**RE: 3.6 GHz band legislative instruments consultation**

In reviewing the papers, the SSWG wishes to draw to your attention to an apparent anomaly with the C-Band filter characteristics on Earth Station receivers in the *Radiocommunications Advisory Guidelines (Managing Interference from Spectrum Licensed Transmitters — 3.4 GHz Band) 2015* (paper RAG Tx 3.4 GHz).

Amended Table 1: Minimum frequency response of Earth receive station's RF filter

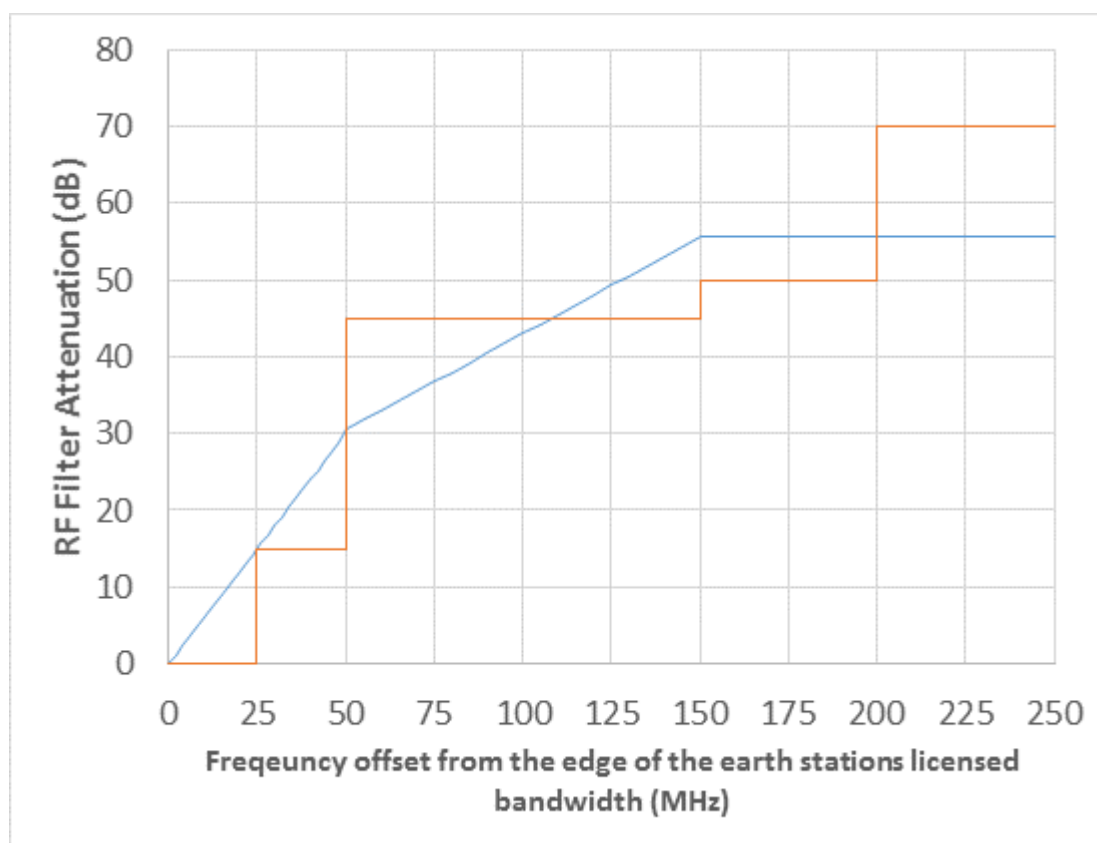
In Section 4.3 *Protection requirements – Earth receive stations operating in the 3600-4200 MHz band for fixed-satellite services*, the SSWG has identified an unexpected step function behaviour in Table 1. In reviewing this table Telstra has offered the following solution: in the second row of the table, 50 MHz should be subtracted from the offset value, given that row applies from 50 MHz to 150 MHz. If this amendment is made to the table, then the step function, with the unexpected steps at both 50 MHz and 150 MHz disappear, resulting in alignment with the FCC filter mask which was proposed by the ACMA in the TLG consultation (refer to page 34 of the TLG document Ver 4). The amended table and ensuing plot are attached to this letter. We understand that both Telstra and Foxtel will also be pointing this out in their submissions.

The SSWG also notes that the wording in the table heading 'Frequency offset (MHz) from the lower or upper frequency on the earth receive station licence' is not practical when there are multiple licences associated with the same Earth Station. The previous wording 'Frequency offset from lower edge of Earth station receiver (MHz)' in RAG Tx 3.4 GHz 2015 (and RALI MS39) is better, and in practical terms, these filters operate from the bottom of C-band either 3700 or 3800 MHz and are not generally tuned for a specific receive frequency.

Frequency offset (MHz) from the lower or upper frequency on the earth receive station licence	Rejection (dB)
$\leq 50$	$0.5 + 0.6 \cdot f_{\text{offset}} \text{ (MHz)}$
$50 < f_{\text{offset}} \leq 150$	$30.5 + 0.25 \cdot (f_{\text{offset}} - 50) \text{ (MHz)}$
$150 < f_{\text{offset}} < 200$	55.5
$\geq 200$	70

Blue line – Corrected Table 1, aligning with FCC mask
